TO:	FROM:
ALL BIDDERS	Luis Ponce, P.E.
COMPANY:	DATE:
	October 5, 2020
ADDRESS:	TOTAL NO. OF PAGES INCLUDING COVER:
	16
RE:	
City of Ferndale	
Addendum 1	
Complete Streets Project	
City Project Number ST2019-02	
TIB Project Number C-W-985(001)-1

**ADDENDUM NO. 1**  
**To the Contract Provisions for**  
**CITY OF FERNDAL, WASHINGTON**

**Complete Streets Project**  
**City Project Number ST2019-02**  
**TIB Project Number C-W-985(001)-1**

9  
of 23

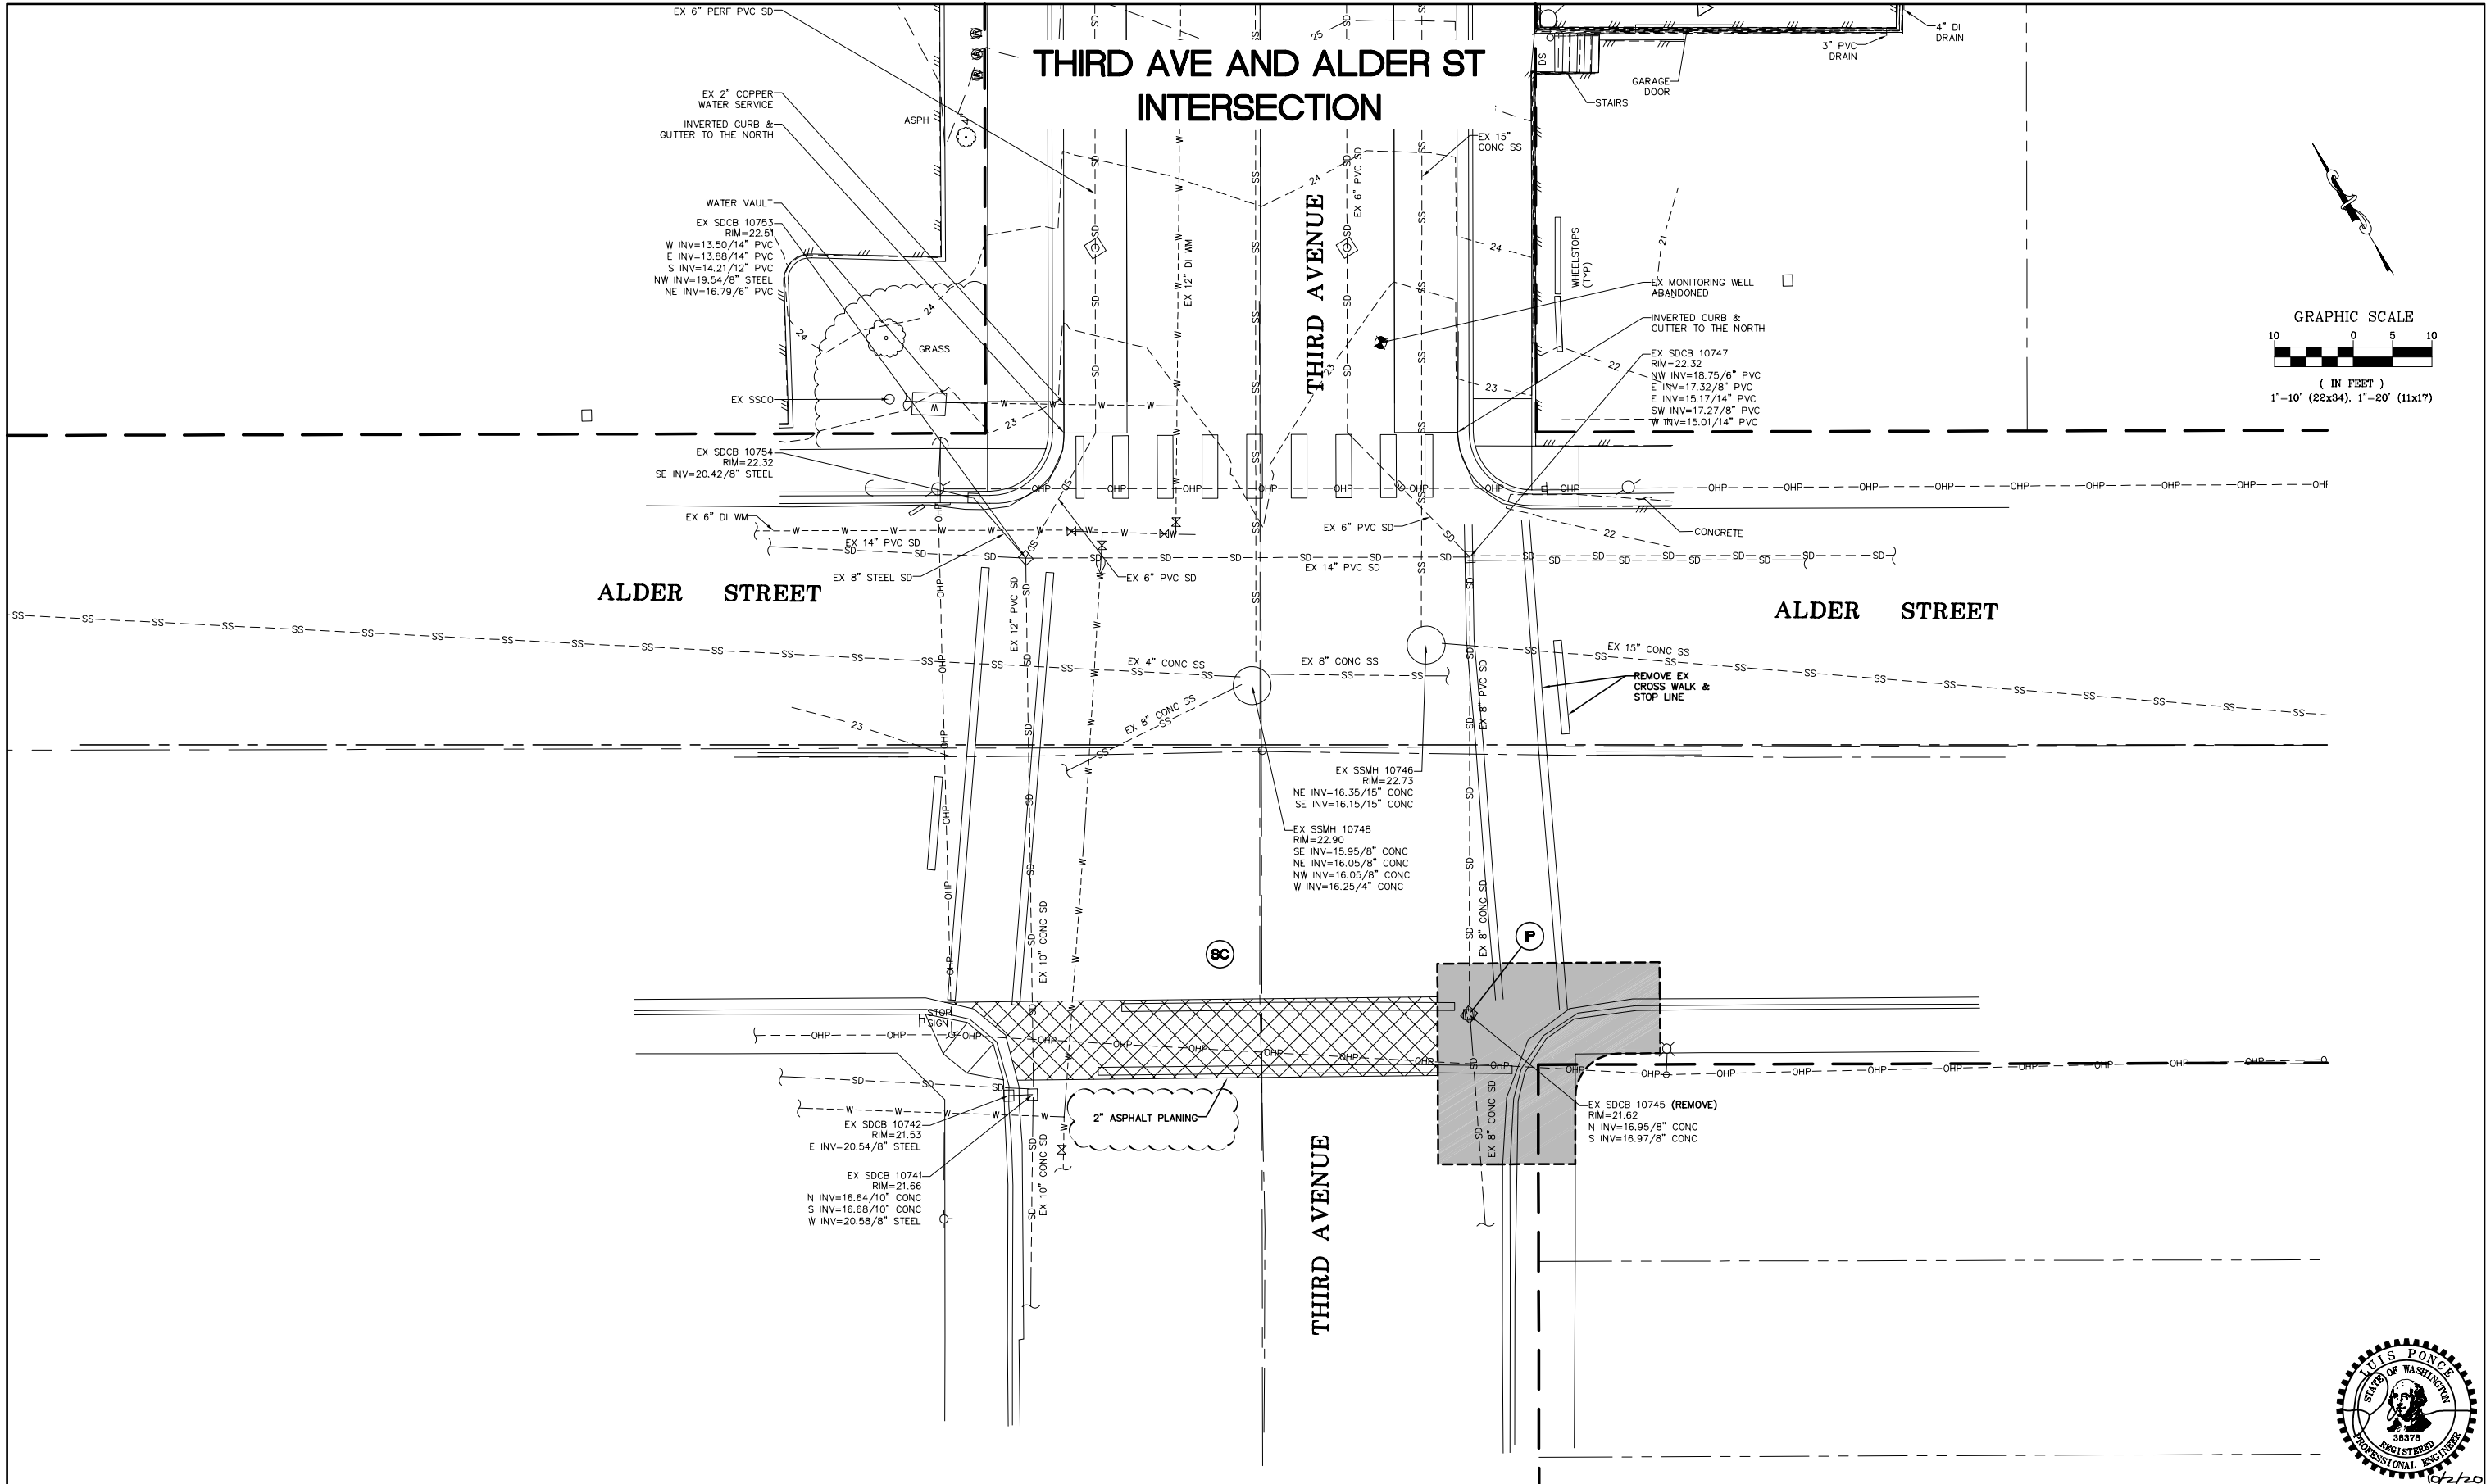
##### Sheet 9

- 2" asphalt planing label was added for clarity.
